11869A RF PLUG-IN ADAPTER

MANUAL PART NO. 11869-90006
Microfiche Part No. 11869-90007

SECTION VII
MANUAL BACKDATING CHANGES

Figure 7-3. 11869A Major Assemblies

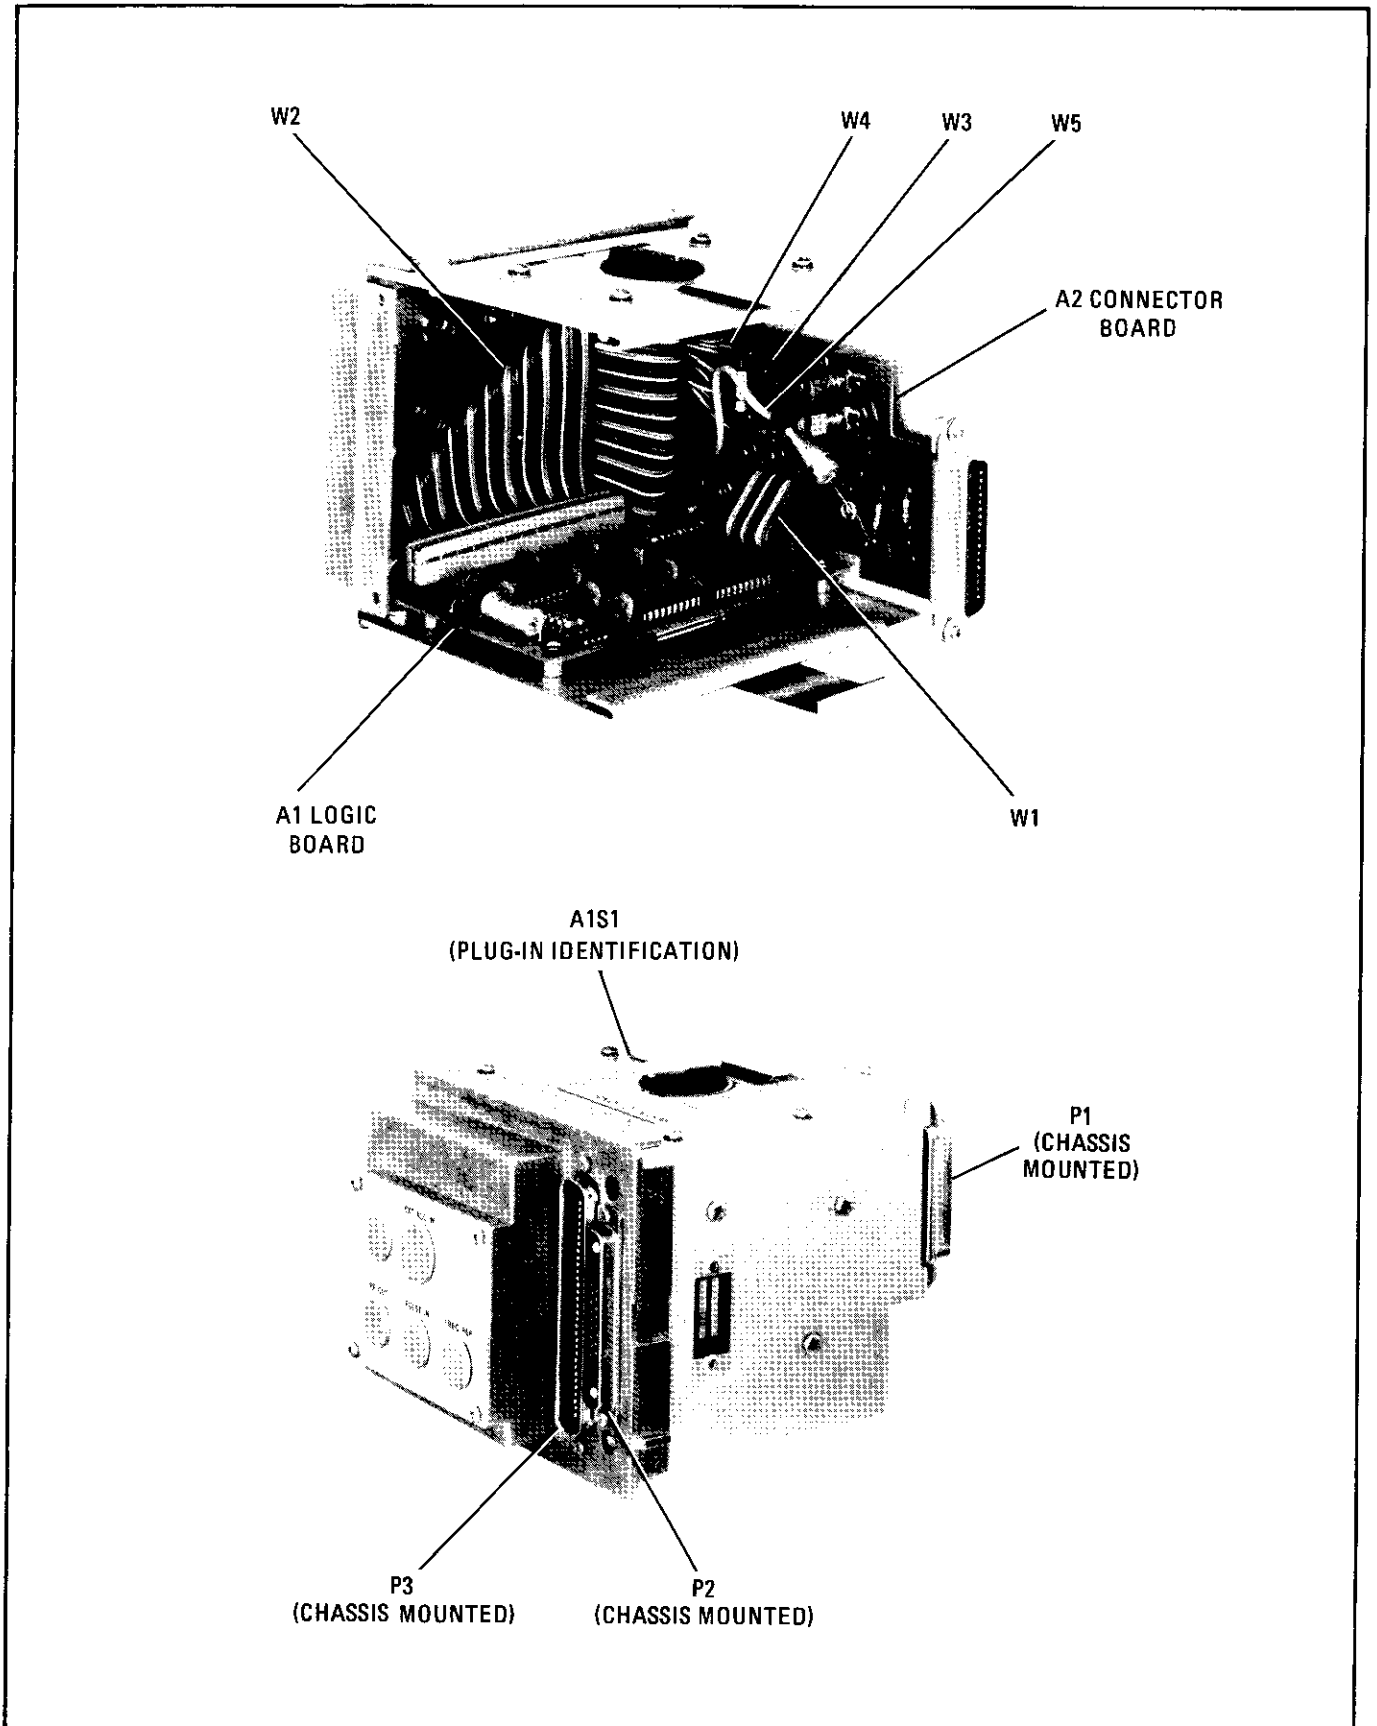
Page 8-24, Figure 8-11:

Replace Figure 8-11 with **11869A Major Assemblies** from this section.

Figure 7-4. A2 Connector Board Parts Location Diagram (CHANGE C)

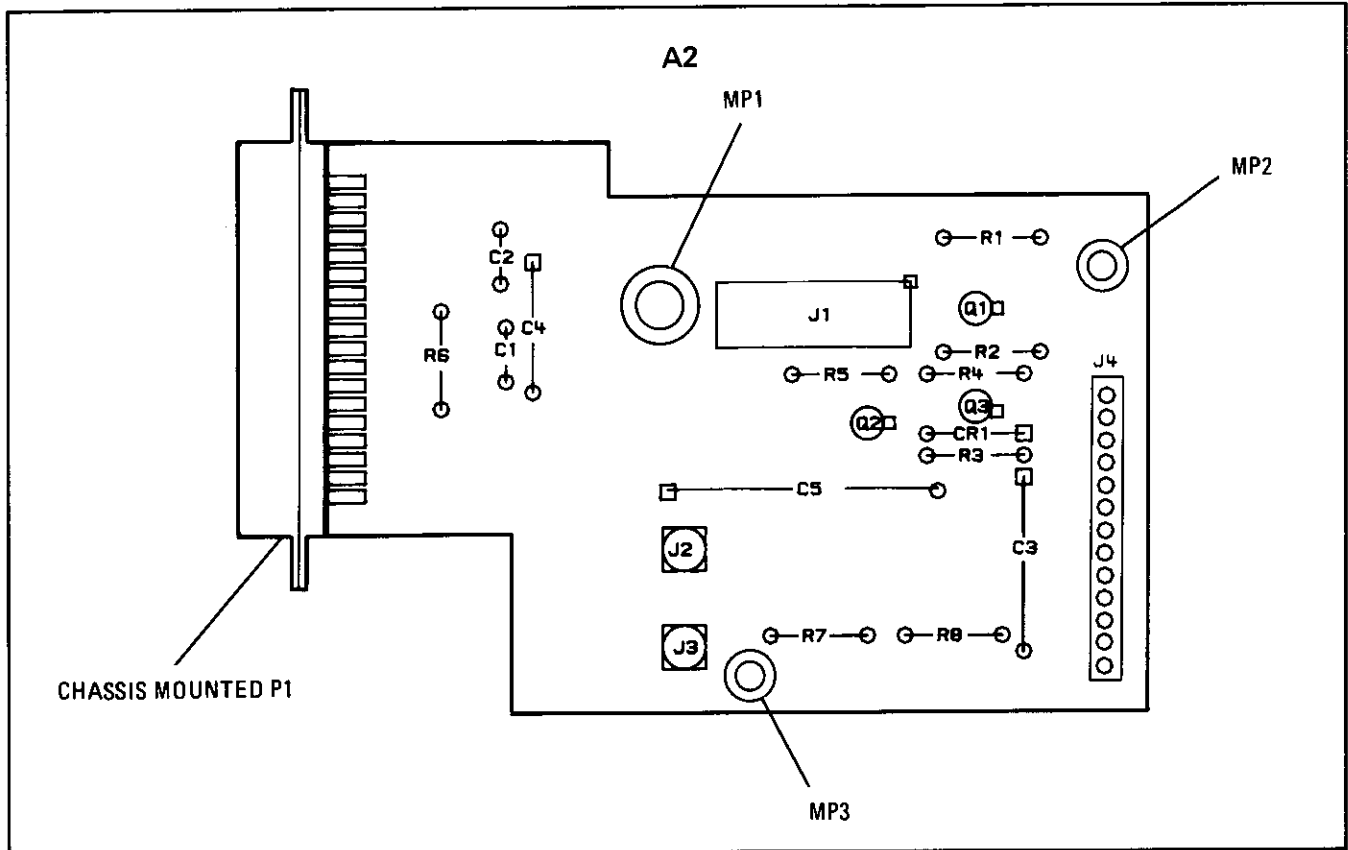
Page 8-18, Figure 8-8:

Replace Figure 8-8 with the **A2 Connector Board Parts Location Diagram (CHANGE C)** in this section.

Figure 7-5. P/O A2 Connector Board Schematic (CHANGE C)

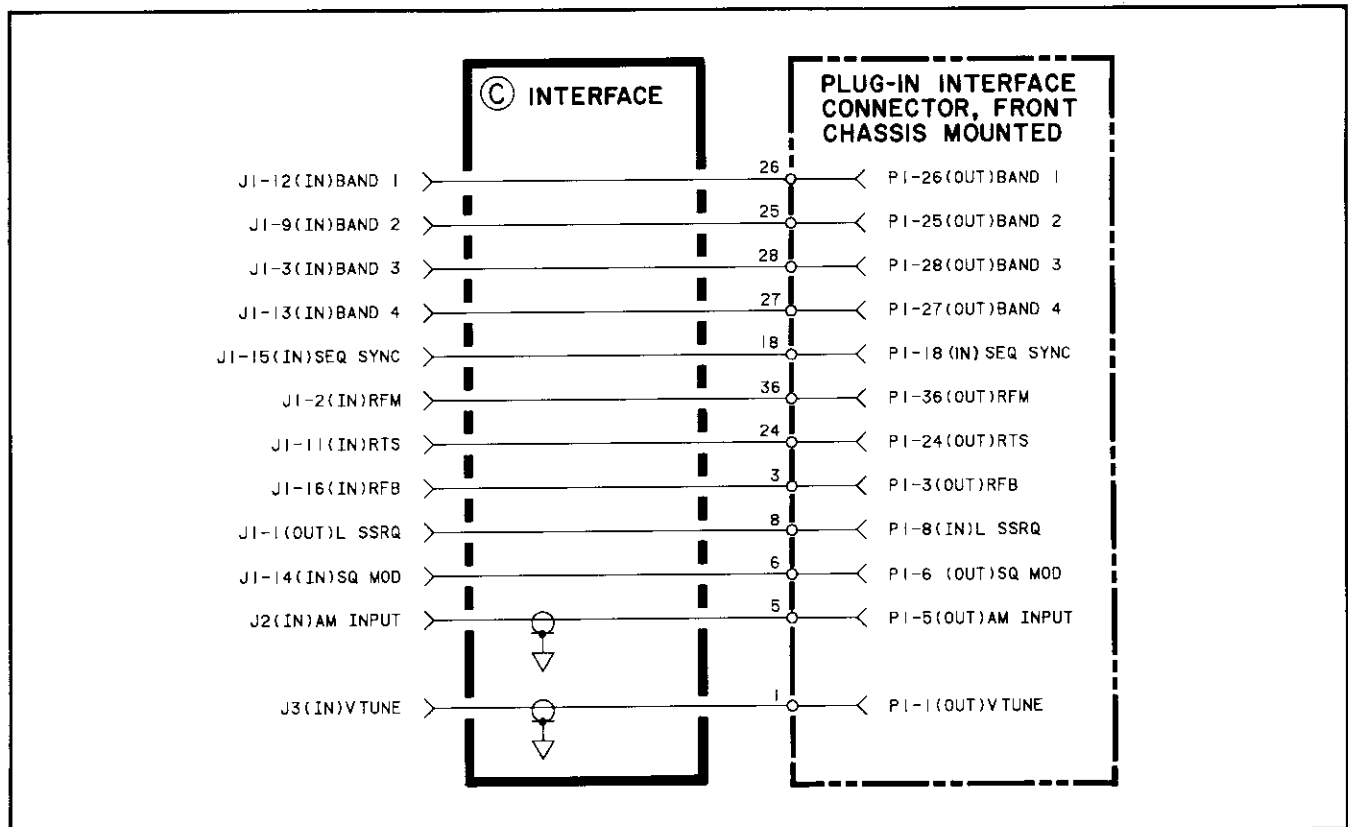
Page 8-21, Figure 8-9:

Change A2 to HP Part Number 11869-60016.

Change the A2 Connector Board Schematic according to the partial schematic **P/O A2 Connector Board Schematic (CHANGE C)** in this section.

Figure 7-6. Cable Interconnect Schematic (CHANGE C)

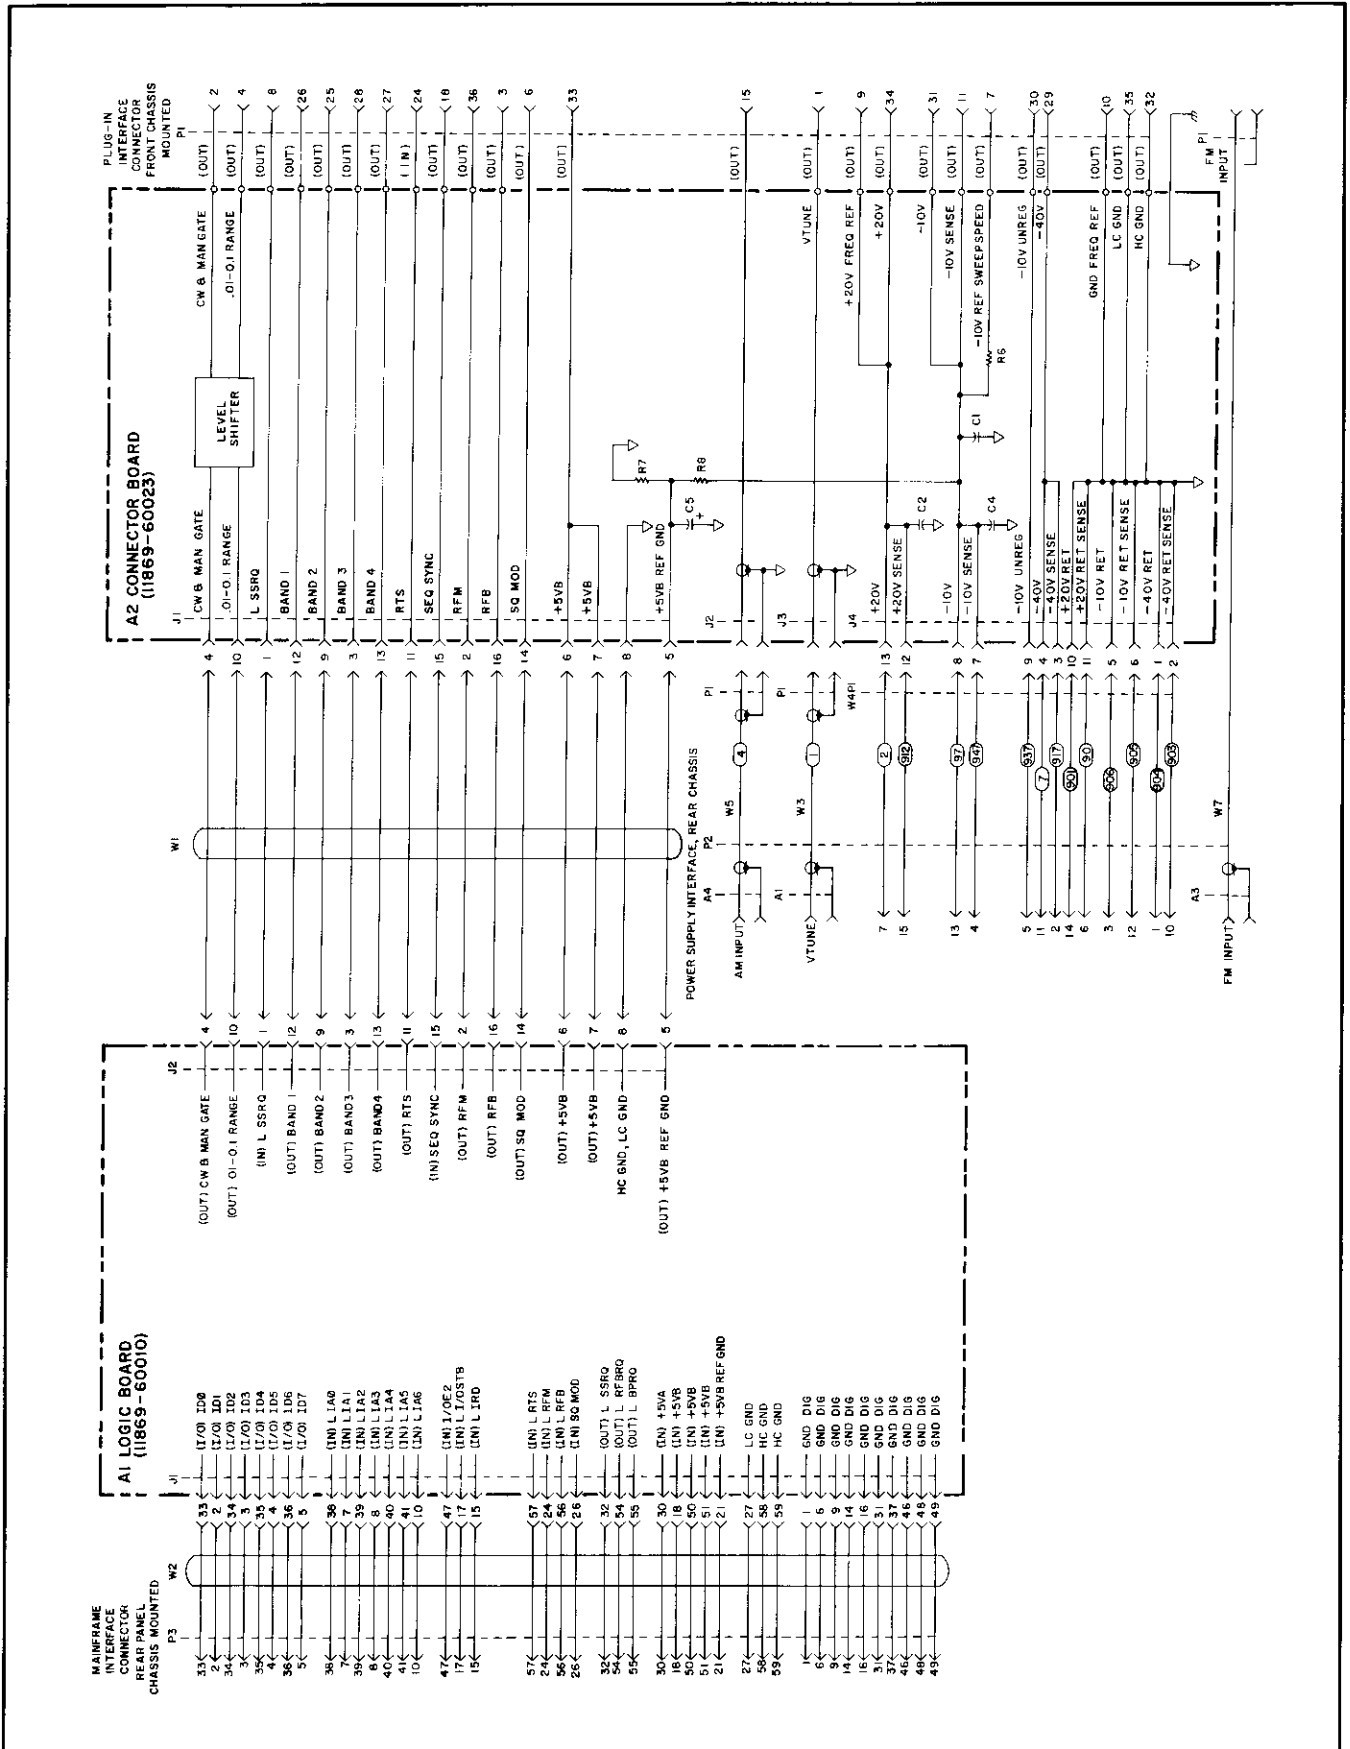
Page 8-23, Figure 8-10:

Replace Figure 8-10 with the **Cable Interconnect Schematic (CHANGE C)** in this section.

Figure 7-7. A2 Connector Board Parts Location Diagram (CHANGE D)

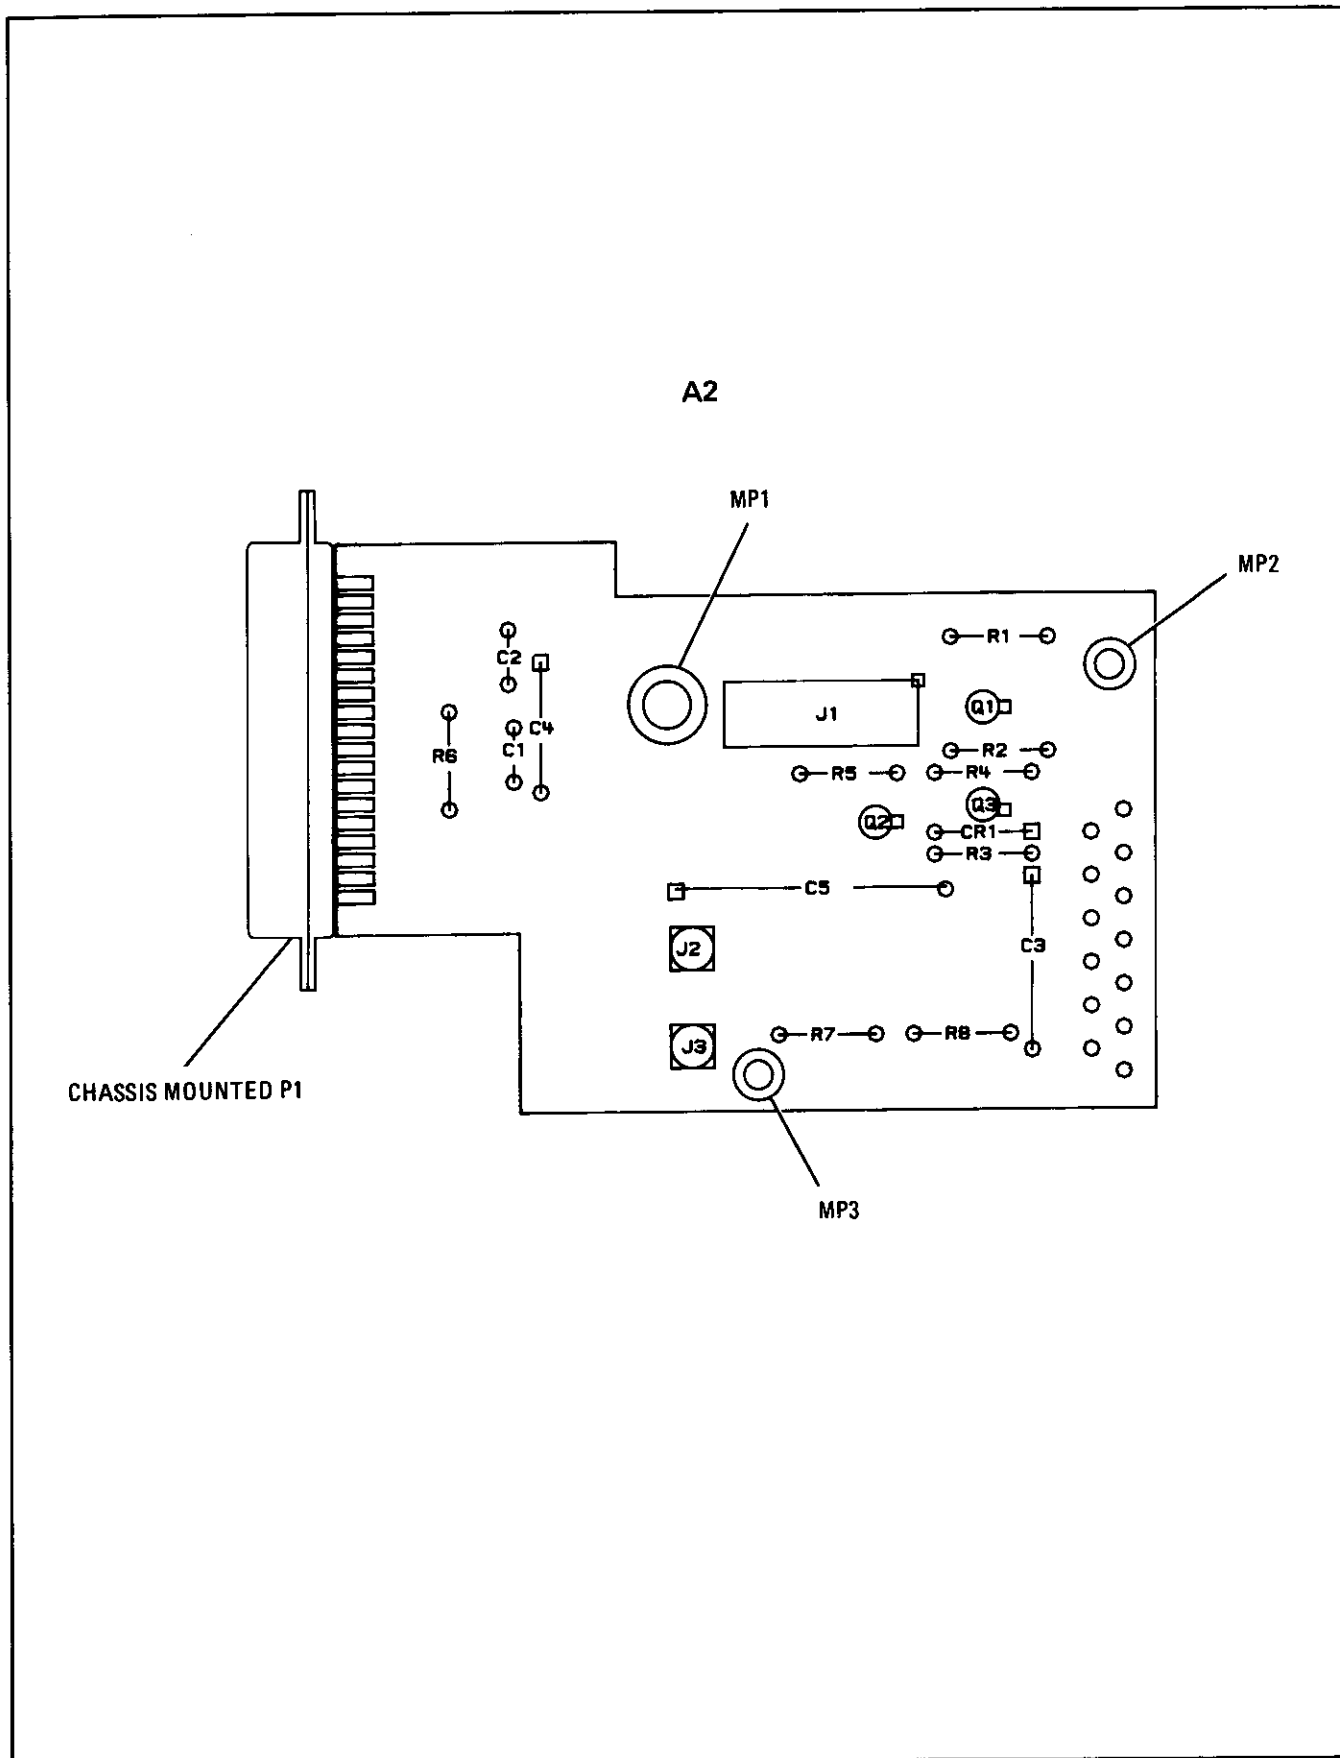
Page 8-18, Figure 8-8:

Replace Figure 8-8 with the **A2 Connector Board Parts Location Diagram (CHANGE D)** in this section.
